# Access Compliance Report

## Public Rights-of-Way

### (Curb Ramps)

Intersection ID: 10026441	Main Street: FARMHURST_DR	Cross Street: N/A	Location: NE
ADA ID: 15DD789031D5	Ramp Type: PerpDiag	Initial Pass/Fail: Fail	Overall Compliance: No
			Severity Score: 21.25

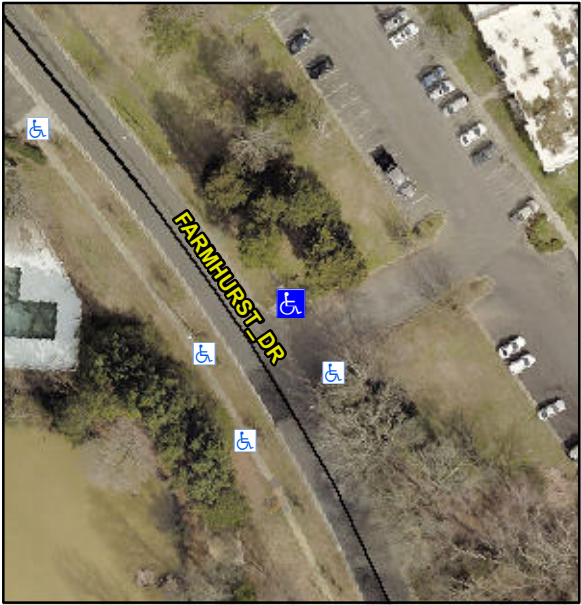
Codes/Mitigation Info/Possible Solution			Field Measurements/Component Compliance		
	Possible Solutions:		<b>Compliance</b>	<b>Description</b>	<b>Data</b>
	<b>Remove &amp; Replace Curb Ramp With Two New Directional Ramps or Equivalent.</b>		N/A	Ramp Length (in)	91.0
			No	Ramp Width (in)	41.0
			N/A	Flare Type LT	N/A
			N/A	Flare Slope LT (%)	N/A
			N/A	Flare Traversable LT?	N/A
			N/A	Landing Length (in)	N/A
			N/A	Landing Width (in)	N/A
			N/A	Landing Slope (%)	N/A
			N/A	Landing X Slope (%)	N/A
<p>Surveyor Notes:</p> <p>N/A</p> <p>PROW/ADA:</p> <p>Not Found, R304.5.1, R304.2.2</p>			N/A	Flare Type RT	N/A
			N/A	Flare Slope RT (%)	N/A
			N/A	Flare Traversable RT?	N/A
			N/A	DWS Provided?	N/A
			N/A	DWS Contrast?	N/A
			N/A	DWS Length (in)	N/A
			N/A	DWS Full Width?	N/A
			N/A	DWS Offset (in)	N/A
			N/A	Shared Landing?	N/A
			N/A	Gutter Ponding?	N/A
			N/A	Gutter Lip Ht (in)	N/A
			N/A	Painted X Walk1?	No
				X Walk 1 Direction	To SW

N/A	X Walk 1 Width (in)	N/A
				X Walk 1 Slope (%)	1.5
				X Walk 1 X Slope (%)	2.3
			N/A	Ramp inside XWalk1?	N/A
				Road Slope (%)	0.5
				Road X Slope (%)	1.2
			N/A	Any Obstructions?	N/A
				Obstruction Type	
					N/A
					N/A
					N/A
					N/A
					N/A
					N/A
					N/A
					N/A
					N/A
Total Cost:		\$ 3200.00
